# ***Next Generation Nuclear Plant***

## ***Risk-Informed Performance-Based Licensing Approach***

### ***Responses to LBE Actions***

July 10, 2012

# Comparison of NGNP and RAI LBE-37 F-C Curves

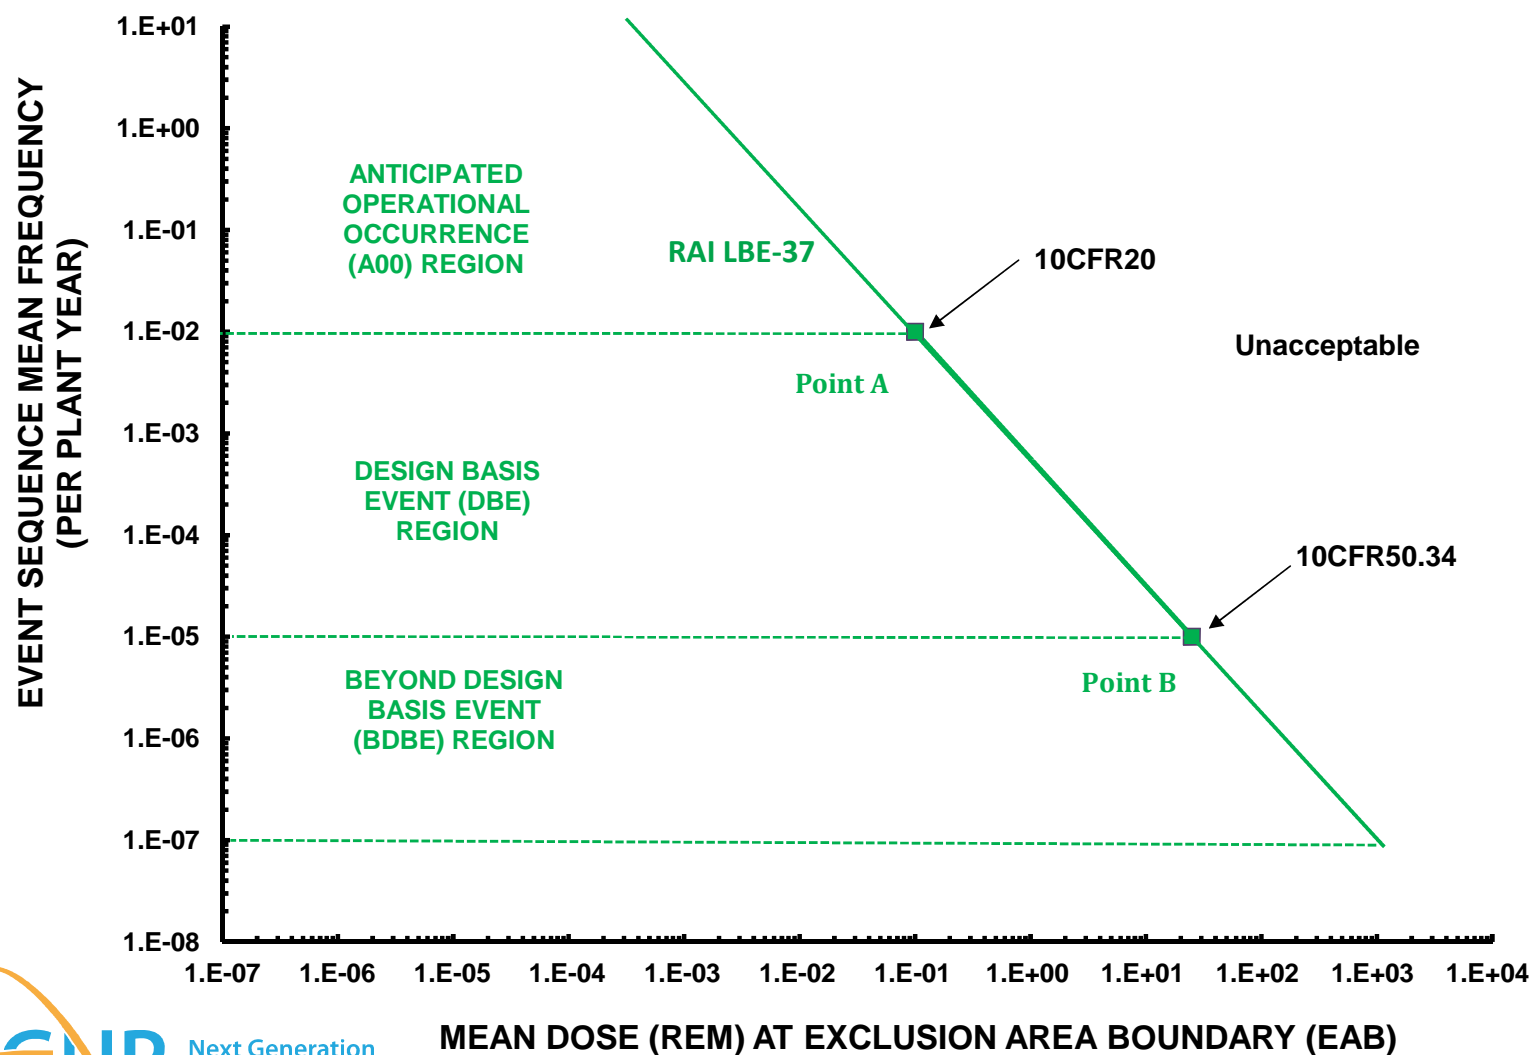
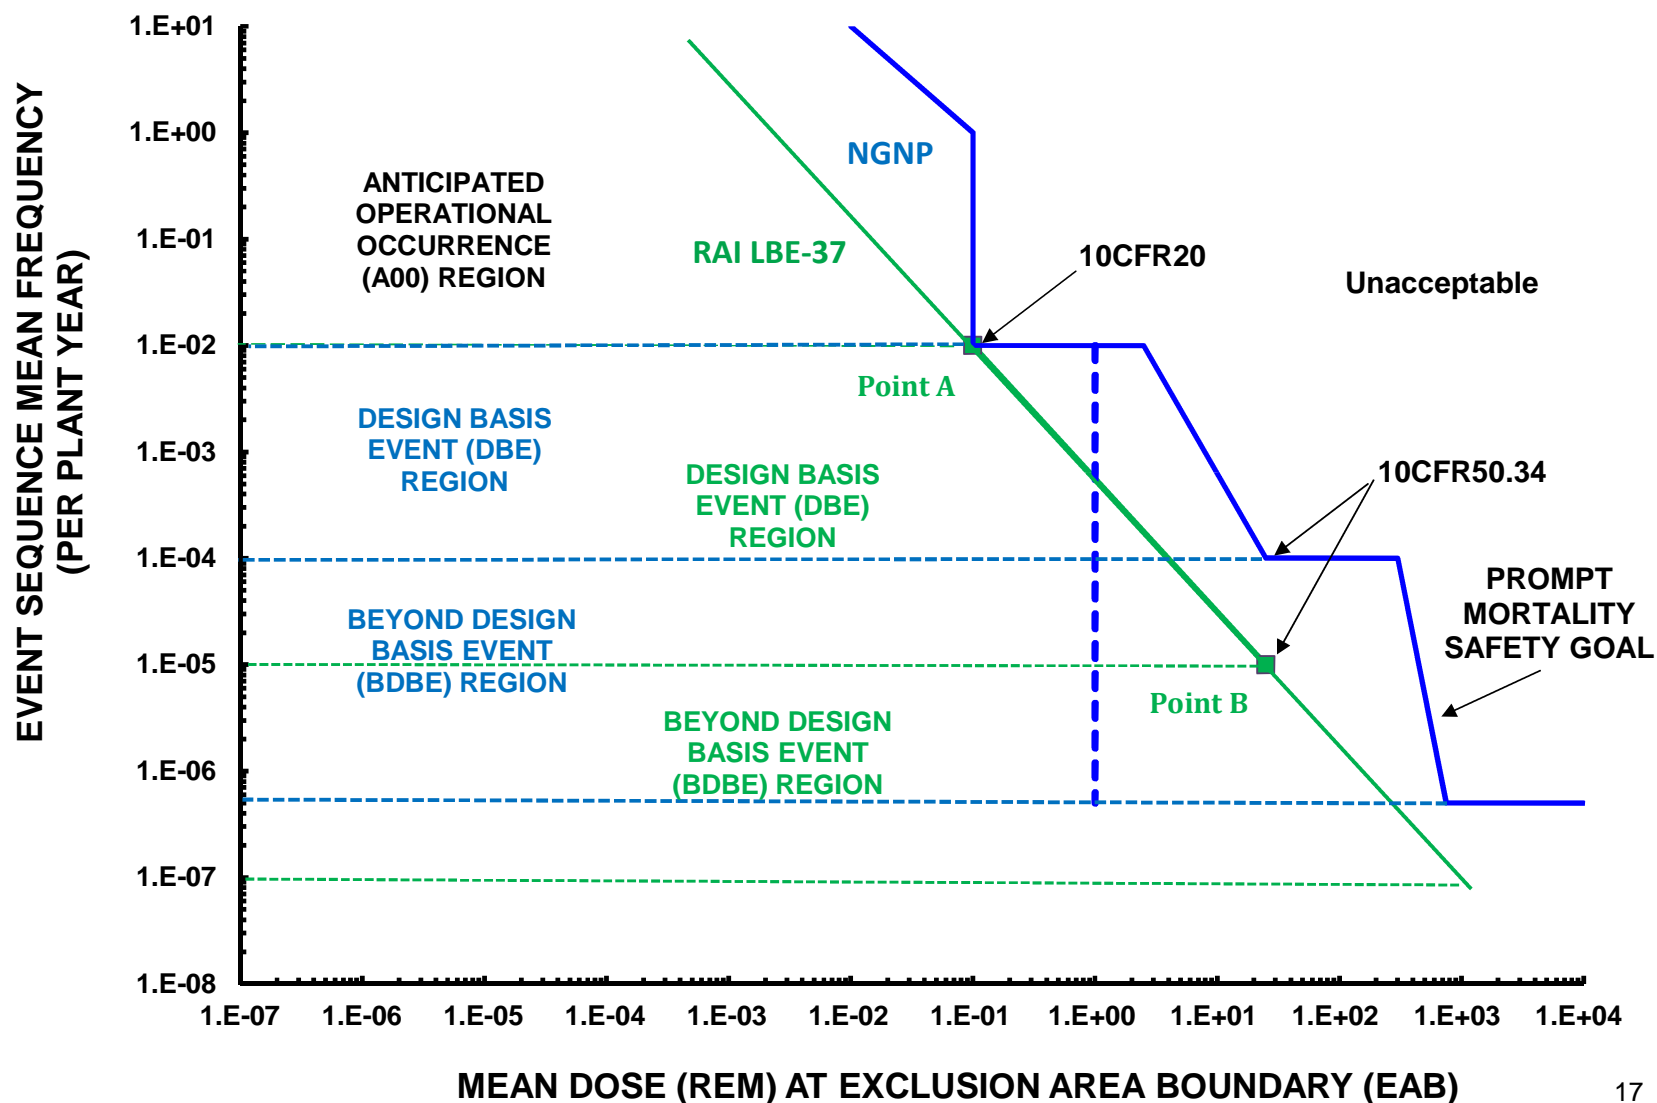
- **Action** - NGNP will plot the staff proposed curve (in RAI-37) against the NGNP curve.
- **Response** – Next slides

## RAI LBE-37

Describe what effect, if any, a revision to frequency-consequence curve would have on the likely classification of equipment, related special treatment requirements, and overall design of facility. Assume the following definition of an alternate F-C curve:

- AOO Region Frequency  $>1\text{E}-2$  (point A)  
Dose = 100mrem
- DBE/DBA Region Frequency  $<1\text{E}-2$  and  $>1\text{E}-5$  (point B)  
Dose = 25 Rem
- BDBE Region Frequency  $<1\text{E}-5$  and  $>1\text{E}-7$   
Dose as defined by line

Boundary line between acceptable and unacceptable regions would be straight line connecting points A and B (continuous through AOO and BDBE regions, i.e., allowable dose approaching 0 as frequency increases).

Handling of site-integrated risk versus unit risk remains an outstanding policy issue, so your response should also discuss the sensitivity of the design to use of curve for events affecting multiple units.

## ***RAI LBE-37 Anchor Points Are More in Agreement with NGNP than NUREG-1860***

<b>Anchor Point</b>	<b>NGNP TLRC</b>	<b>RAI LBE-37</b>	<b>Notes</b>
<b>10CFR20 (100 mrem)</b>	<b>Yes</b>	<b>Yes</b>	<b>Agree on need for dose on F-C curve</b>
<b>10CFR50.34 (25 rem)</b>	<b>Yes</b>	<b>Yes</b>	<b>Agree on need for dose on F-C curve</b>
<b>QHO (300 rem)</b>	<b>Yes</b>	<b>-</b>	<b>Needs to be on F-C curve</b>
<b>QHOs (750 rem)</b>	<b>Yes</b>	<b>-</b>	<b>Needs to be on F-C curve</b>

## ***RAI F-C Curve Has Larger DBE Region and Inconsistent with Prompt QHO***

Anchor Point	NGNP TLRC	RAI LBE-37	Notes
<b>10CFR20</b> (100 mrem)	$10^{-2}/\text{pl-yr}$	$10^{-2}/\text{pl-yr}$	Agree on need for dose on F-C curve <b>Same AOO region term</b> <b>Same lower frequency</b> <b>Need agreement on curve</b>
<b>10CFR50.34</b> (25 rem)	$10^{-4}/\text{pl-yr}$	$10^{-5}/\text{pl-yr}$	Agree on need for dose on F-C curve <b>Same DBE term</b> <b>Need agreement on lower frequency</b> <b>Need agreement on curve</b>
<b>QHO</b> (300 rem)	$10^{-4}/\text{pl-yr}$	-	<b>RAI curve needs consistency with QHO</b>
<b>QHOs</b> (750 rem)	$5 \times 10^{-7}/\text{pl-yr}$	-	<b>RAI curve needs consistency with QHO</b>

## ***Observations from Comparison of RAI Anchor Points and FC Curve with NGNP***

- Comparison Agreement
  - Formulation on the per plant year basis
  - Number of regions and terminology consistent with NGNP
  - Selected doses are in regulations and consistent with NGNP's
- Issues
  - Restrictive at high frequencies (US avg. background: 300 mrem from natural causes and 310 mrem from man-made per 2006 NCRP 160)
  - More restrictive at low frequencies than prompt QHO
  - **Design Basis Region extends to  $10^{-5}$ /plant year**
    - **$10^{-5}$ /plant year would limit siting for SSE and lead to more safety-related SSCs**
    - **Coverage below  $10^{-4}$ /plant year provided by DBAs that rely only on safety-related SSCs**
- Overarching concern is a stable, level playing field with other reactor types that are NGNP competitors
- NGNP intends to meet the selected TLRC consequence limits with large safety margins via the PAG design goal at the EAB

# MHTGR LBEs with Uncertainties vs. TLRC

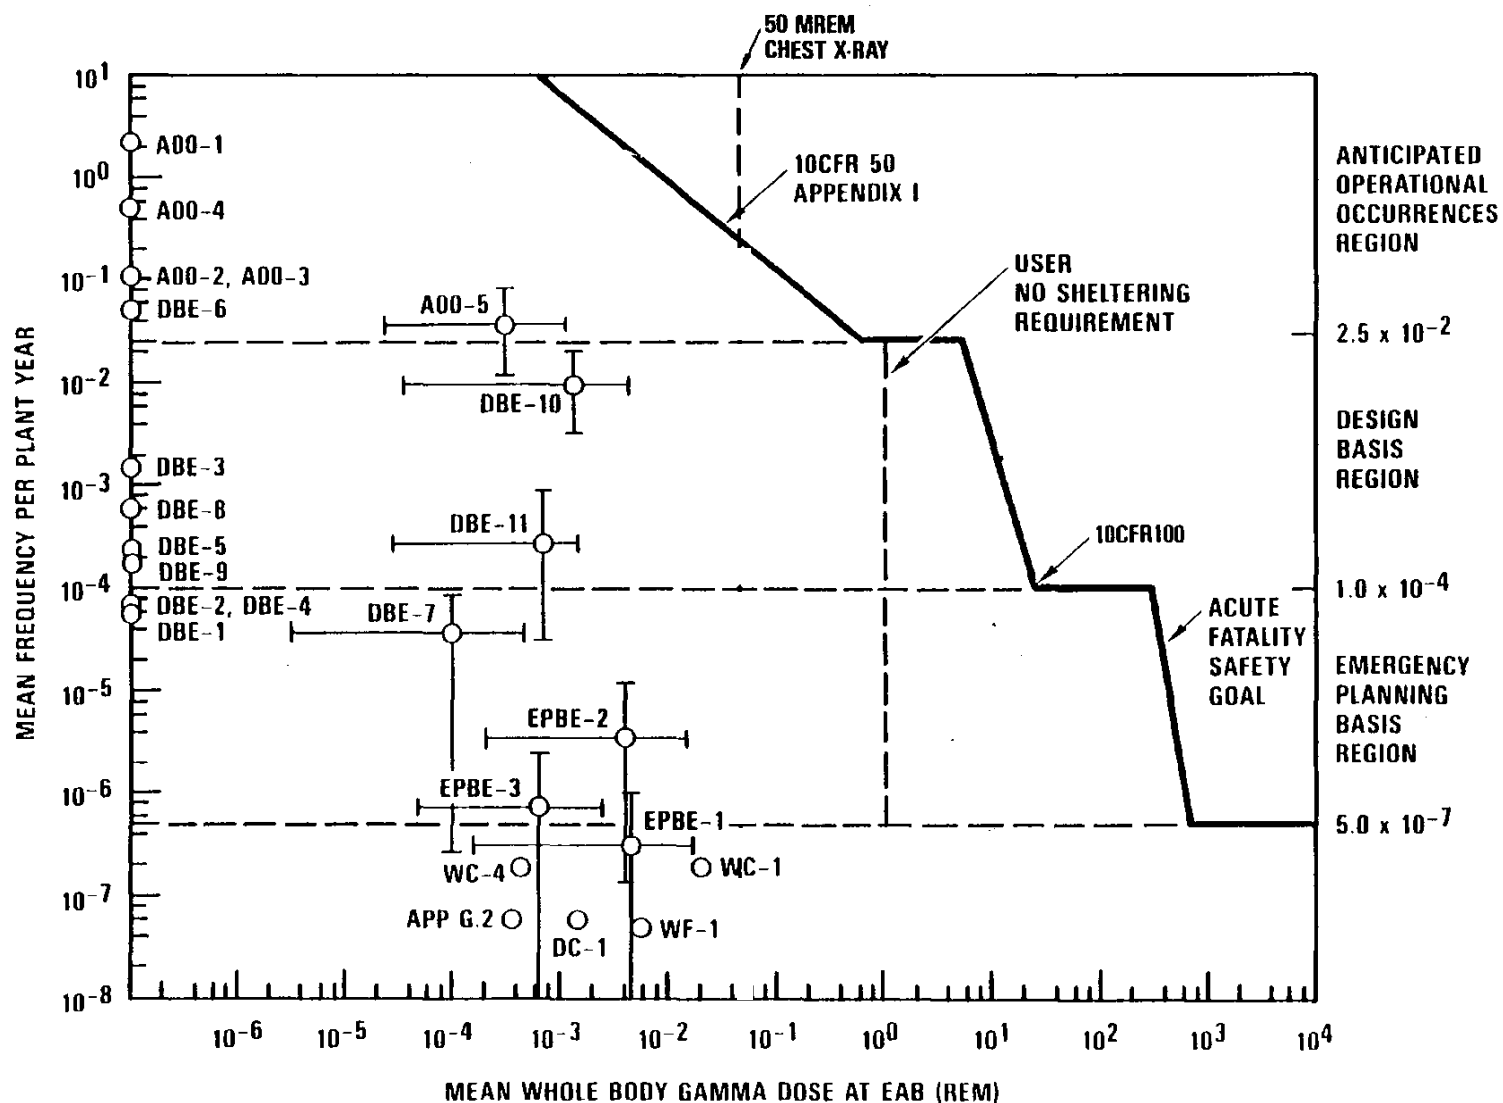
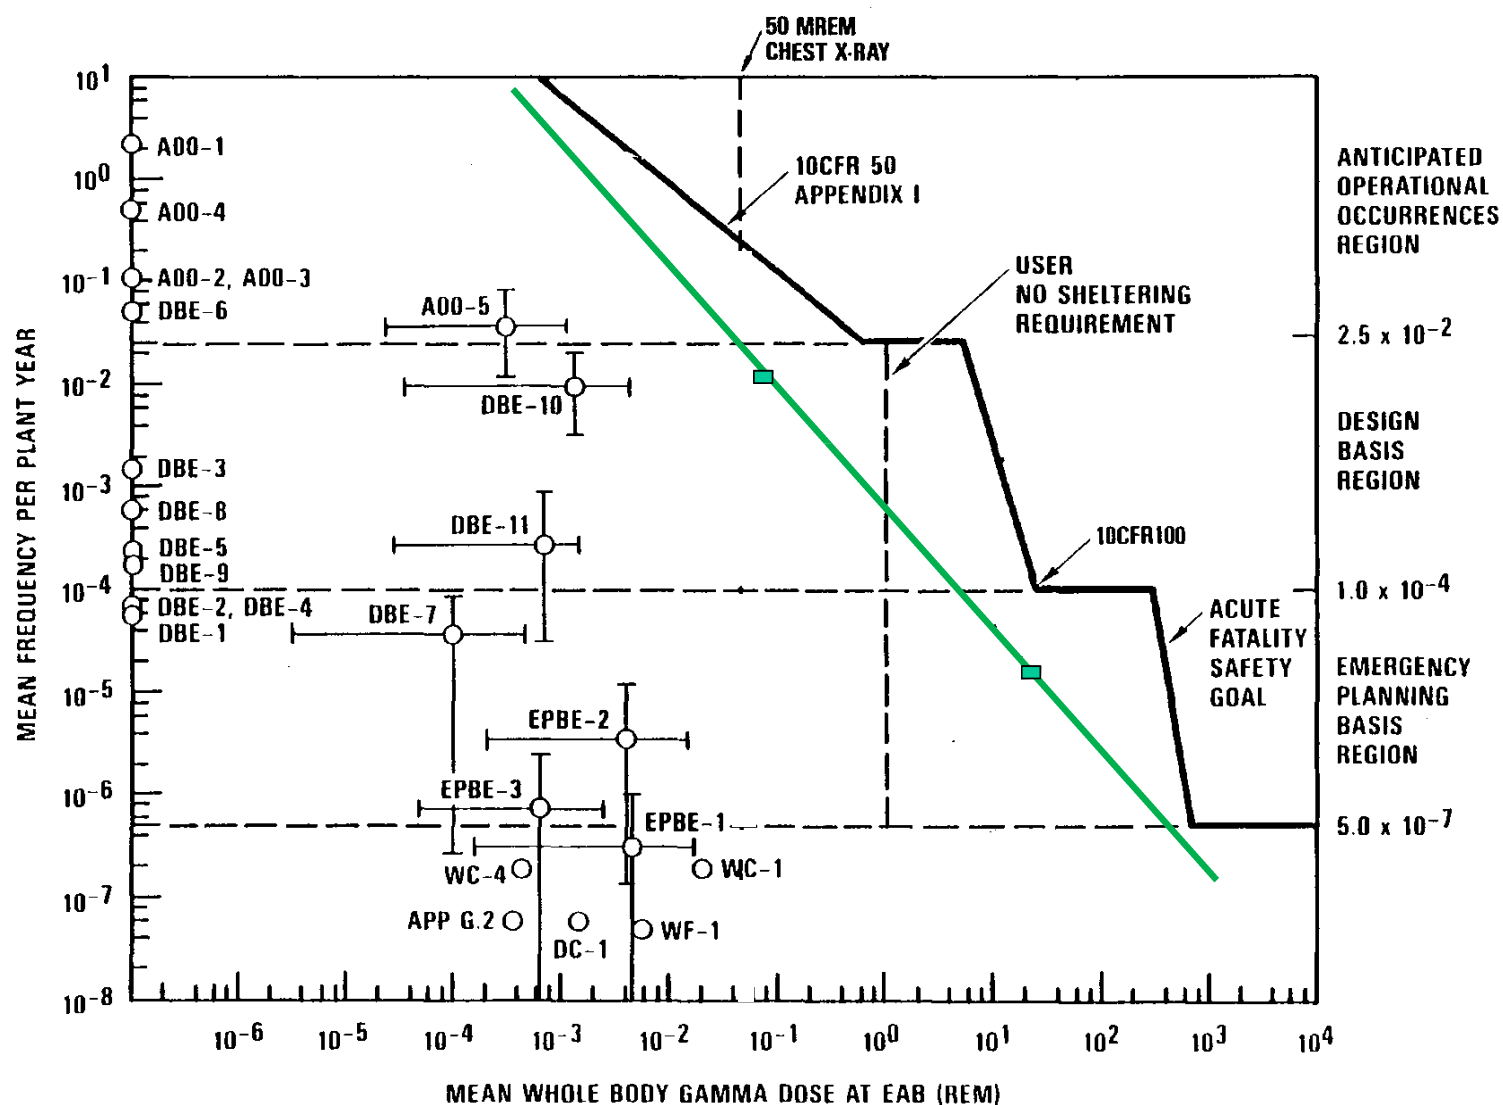
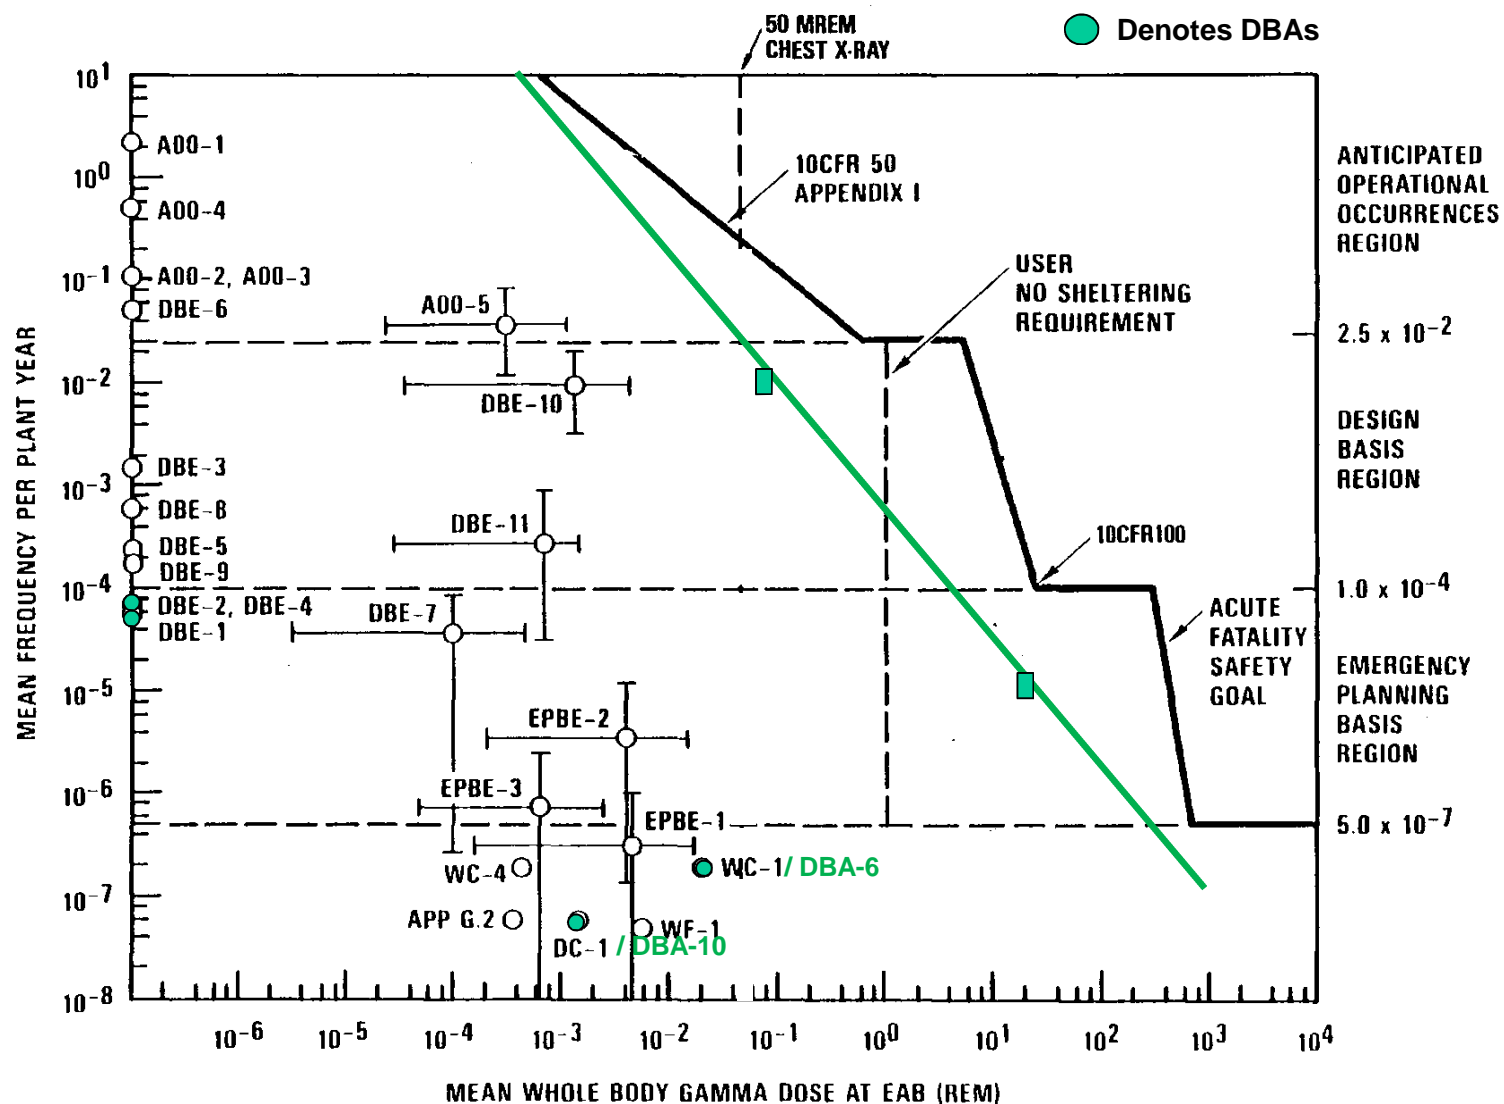
- **Action** - NGNP will plot the MHTGR events with uncertainties shown. NGNP will also indicate which of the DBEs and BDBEs are equivalent to the DBAs derived for evaluation in Chapter 15 with only safety related SSCs successfully responding.
- **Response** – Next slides

## ***MHTGR DBAs Derived from DBEs: 2 Same as DBEs Remaining 9 Collapse into 6 Lower Frequency Events***

3 Same as DBEs; 3 of 5 with Lower Frequencies Have Doses

# MHTGR LBE Impacting All Four Reactors

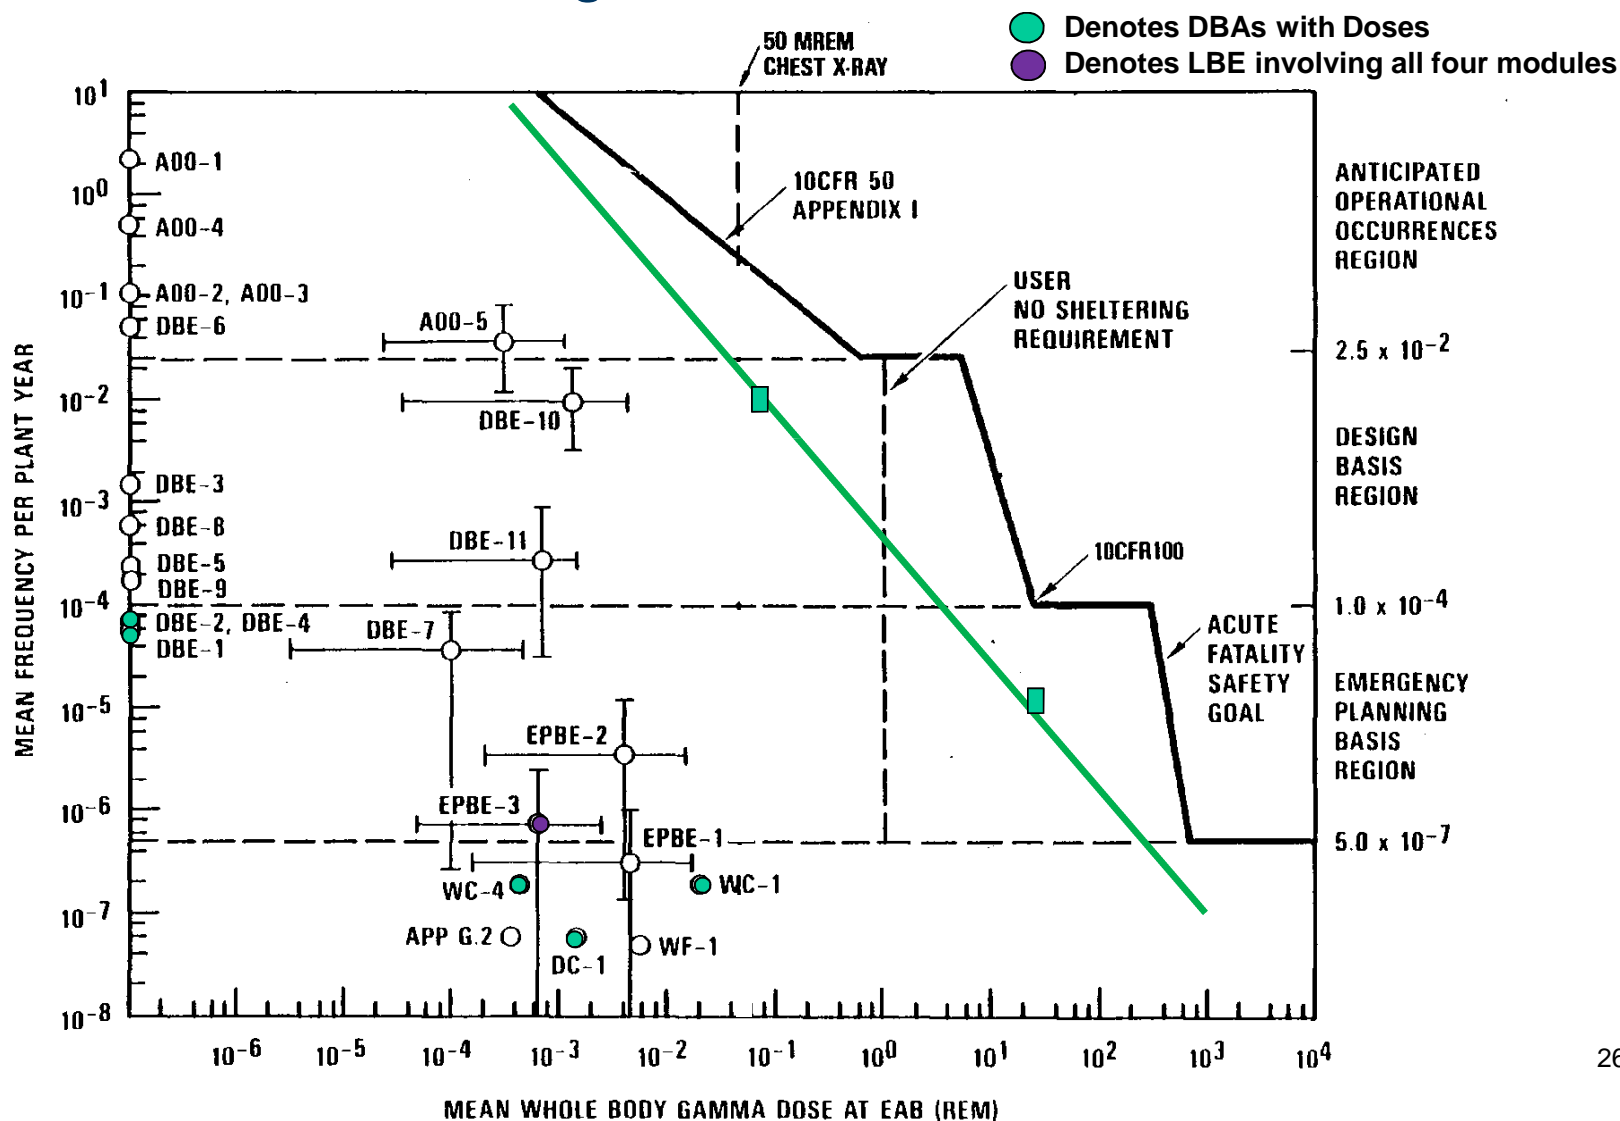
- **Action** – For the next meeting, NGNP will provide some examples of this approach for the MHTGR reference plant design of four reactor modules per plant with respect to the frequency-consequence (F-C) curve to illustrate the conservatism of the approach.
- **Response** – Next slide

## EPBE 3 is EQ >SSE Leading to HPB Leaks/Breaks w/o Forced Cooling
